SERVICE BULLETIN
CHECKING OR REPLACEMENT
OF THE FUEL PUMP ASSEMBLY PART NO. 996 596
ON ROTAX® ENGINE TYPE 912 (SERIES)
SB-912-031

MANDATORY

Checking or replacement of the fuel pump assembly part no. 996 596.

Bild / Fig. 1

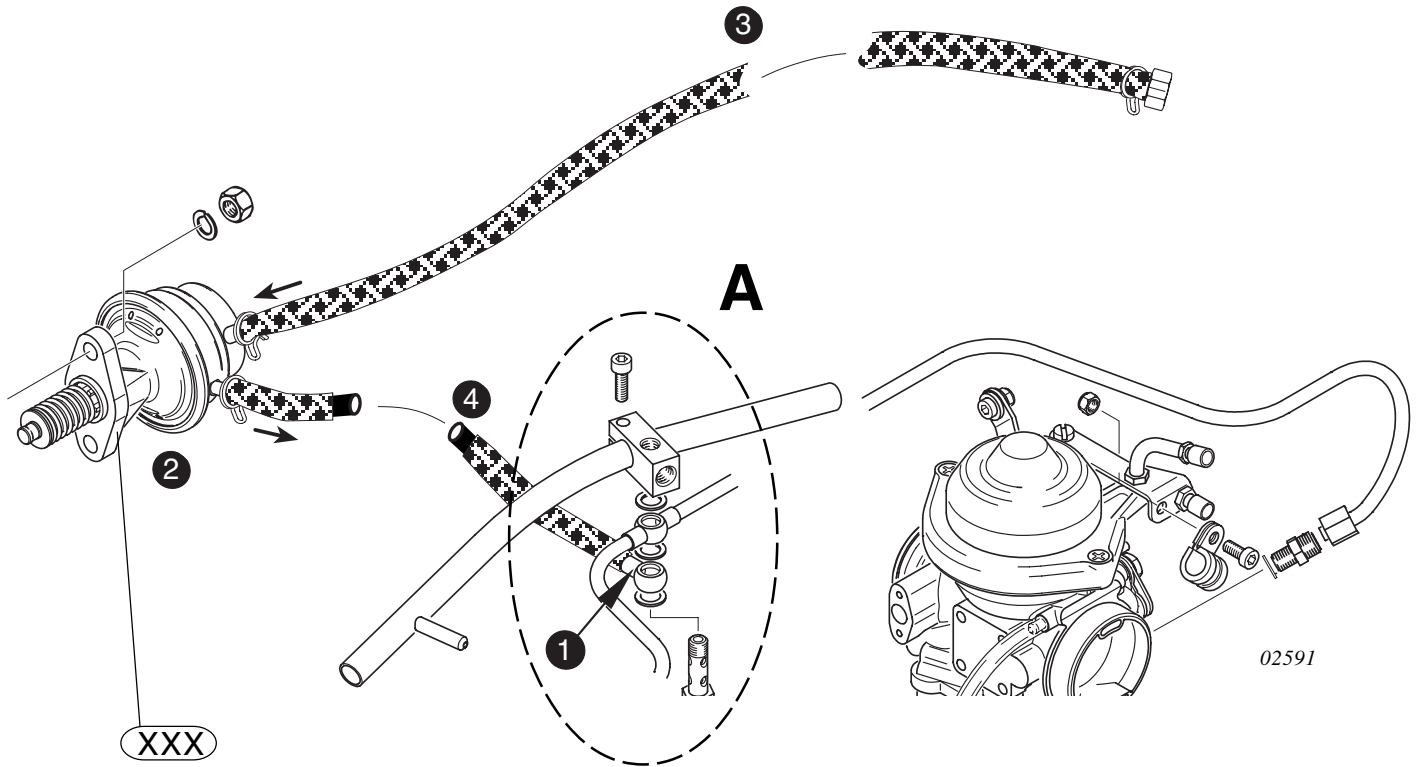
It has been noticed that leaking at the hose nipple (1) is feasible.

- Inspection of fuel pump assy. (2) inclusive feeding line (3) and pressure line (4) for cracks.
- If cracks are detected, the fuel pump assy. part no. 996 596 must be replaced without delay by the fuel pump assy. part no. 996 597.

- Conduct leakage test of fuel pump assy. (2) inclusive feeding line (3) and pressure line (4) for leakage:

- Conduct leakage test of fuel pump assy. (2) inclusive feeding line (3) and pressure line (4) for leakage. Therefore admit at least 0,2 bar to max. 0,4 bar pressure on the fuel system by the additional electric fuel pump or suitable equipment.

- Conduct leakage test of fuel pump assy. (2) inclusive feeding line (3) and pressure line (4) for leakage. Therefore a test run and leakage test has to be performed.
- If leakage is detected, the cause of failure has be found and if necessary the fuel pump assy. part no. 996 596 must be replaced without delay by the fuel pump assy. part no. 996 597.
